**Committee of Experts on the Transport of Dangerous Goods
and on the Globally Harmonized System of Classification
and Labelling of Chemicals****Sub-Committee of Experts on the Transport of Dangerous Goods****Fifty-fourth session**

**Recommendations made by the Sub-Committee on its fifty-first,
fifty-second and fifty-third sessions and pending issues:
transport of gases****Chemicals under pressure: extinguishing agents (UN 3500)****Transmitted by the European Chemical Industry Council (CEFIC)*****Situation**

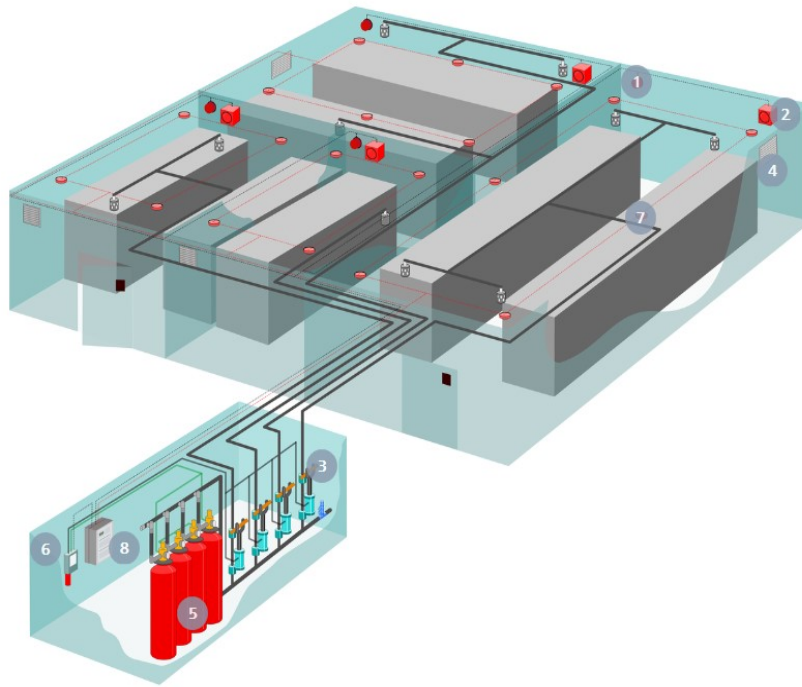
9. Amend P206 as follows (*deleted text is struck through; new text is underlined*):

P206	PACKING INSTRUCTION	P206
This instruction applies to UN Nos. 3500, 3501, 3502, 3503, 3504 and 3505		
Unless otherwise indicated in these Regulations, cylinders and pressure drums conforming to the applicable requirements of Chapter 6.2 are authorized.		
<ol style="list-style-type: none"> (1) The general packing requirements of 4.1.6.1 shall be met. (2) The maximum test period for periodic inspection shall be 5 years. (3) 		
Special packing provisions:		
PP89		
PPXX For fire extinguishing agents assigned to UN No. 3500 the maximum test period for periodic inspection shall be 10 years and the following packing should be allowed: tubes of a maximum water capacity of 450 l.
